TITLE : AIR CONDITIONING - AVIONICS EQUIPMENT VENTILATION - INTRODUCE NON
RETURN VALVE ON GROUND REFRIGERATION UNIT AIR INLET.

This page transmits Revision No. 01 of Service Bulletin No. A320-21-1101.

SERVICE BULLETIN No. : A320-21-1101

REVISION No. : 01 - Jun 27/01

Figure 1 Sheet 1
Modification of the Blowing Duct, Kit 211101A01

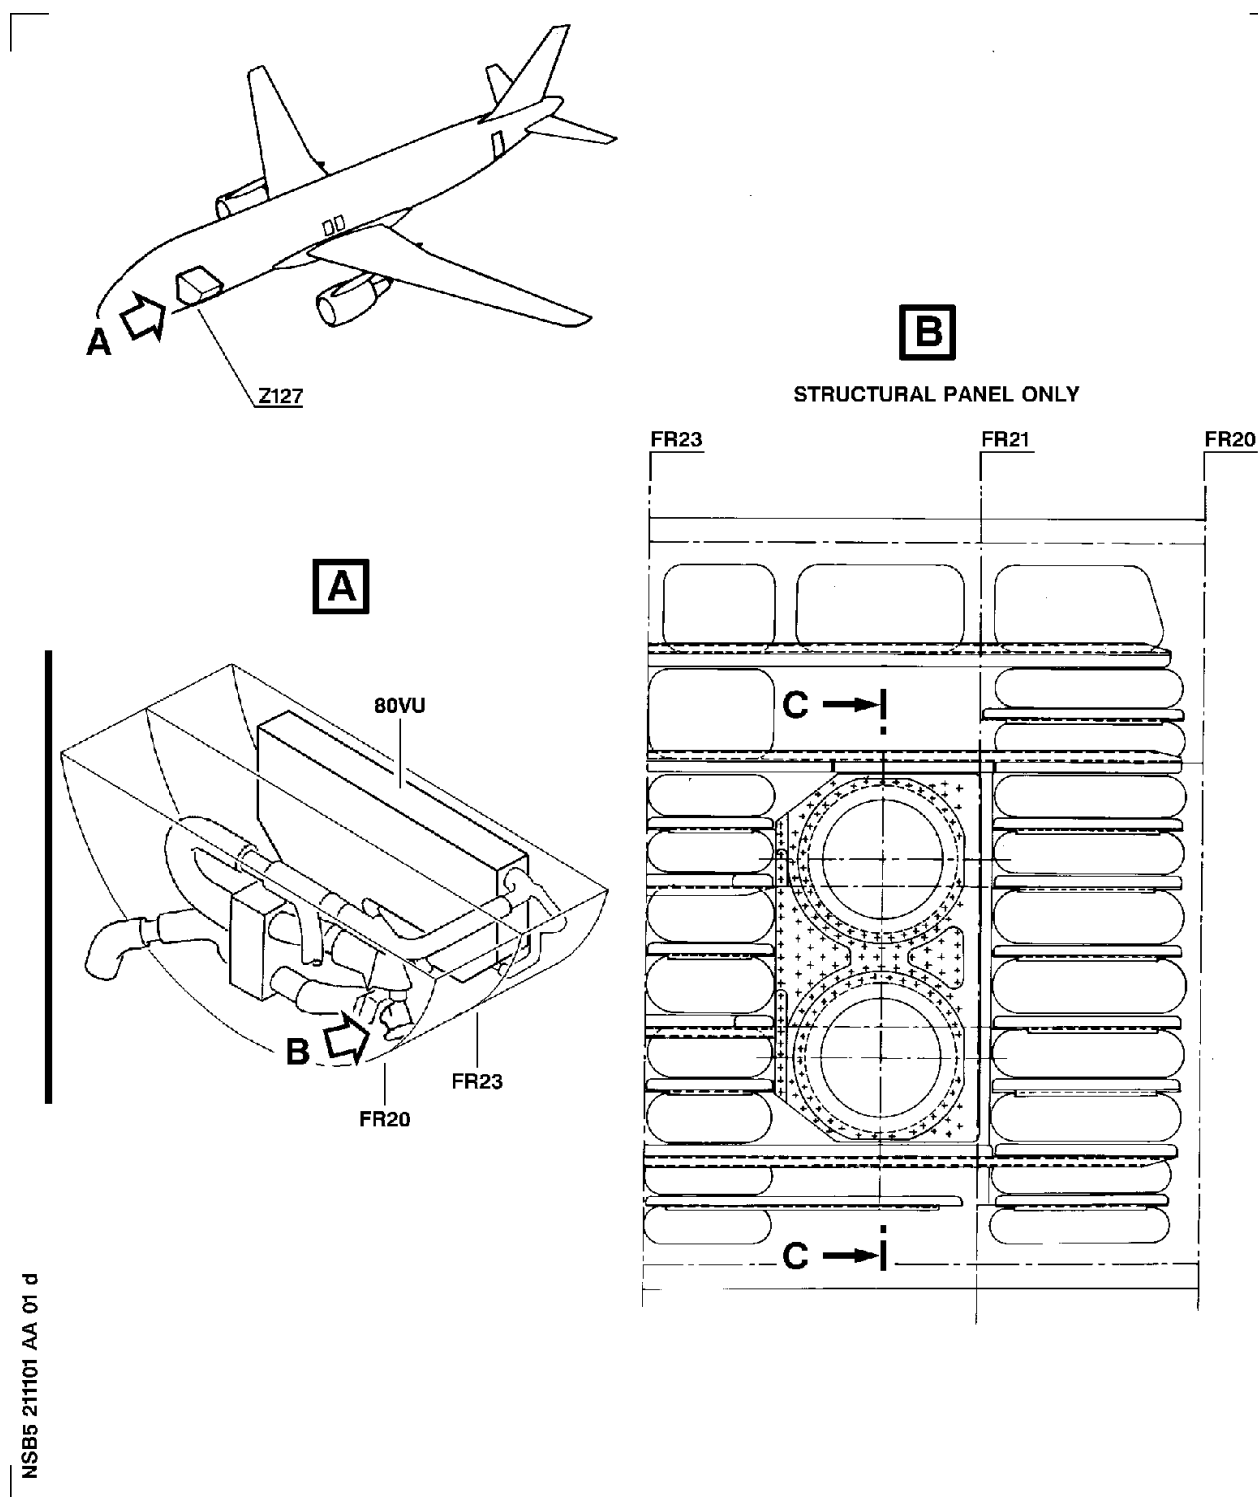
- (a) Replace the blowing duct.
Refer to figure 1 Sheets 1 , 2 and 3
Refer to AMM 21-27-52 Page block 401

1	Air inlet valve		Item (2)	Retain
1	O-Ring	NSA8205-171	Item (9)	Discard
10	Screws	NAS1153E8	Item (10)	Discard

2	Clamps		Item (3)	Retain
1	Sleeve		Item (4)	Retain
1	Clamp	NSA8603-737	Item (5)	Discard
1	O-Ring	NSA8203-260	Item (6)	Discard

1	Filter		Item (7)	Retain
1	Clamp	55220-014-022	Item (8)	Discard
10	Rivets	ASNA2051DCJ3215	Item (15)	Discard
1	Blowing duct	D539141350000	Item (1)	Discard

1	Blowing duct	D5391679100000	Item 1
10	Rivets	ASNA2051DCJ3215	Item 15
1	Clamp	55220-014-022	Item 8
1	Filter		Item (7)
1	O-Ring	NSA8203-260	Item 6
1	Clamp	NSA8603-737	Item 5
1	Sleeve		Item (4)
2	Clamps		Item (3)

1	Air inlet valve		Item (2)
1	O-Ring	NSA8205-171	Item 9
10	Screws	NAS1153E8	Item 10
